State of New Mexico  
Energy, Minerals and Natural Resources

Form C-103  
Revised August 1, 2011

WELL API NO. 30-015-03039
5. Indicate Type of Lease STATE <input checked="" type="checkbox"/> FEE
6. State Oil & Gas Lease No. B-1266
7. Lease Name or Unit Agreement Name GJ WEST COOP UNIT
8. Well Number 028
9. OGRID Number 229137
10. Pool name or Wildcat GJ; 7RVS-QN-GB-S.A.

SUNDRY NOTICES AND REPORTS ON WELLS  
(DO NOT USE THIS FORM FOR PROPOSALS TO DRILL OR TO DEEPEN OR PLUG BACK TO A DIFFERENT RESERVOIR. USE "APPLICATION FOR PERMIT" (FORM C-101) FOR SUCH PROPOSALS.)

GJ West COOP Unit # 28

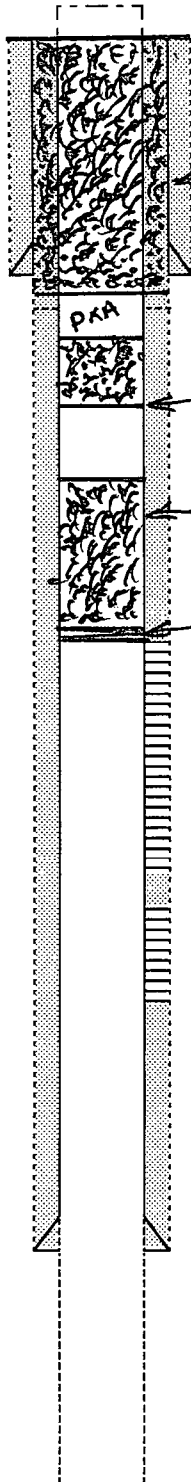
PERF. X CIRC. 130 SX 4. CMT. @ 357'-3'

Pump 35 SX 4. CMT. @ 900'-700' - TAG

Pump 45 SX 4. CMT. @ 2250' - 2010'

SET 5 1/2" CDBP @ 2250'
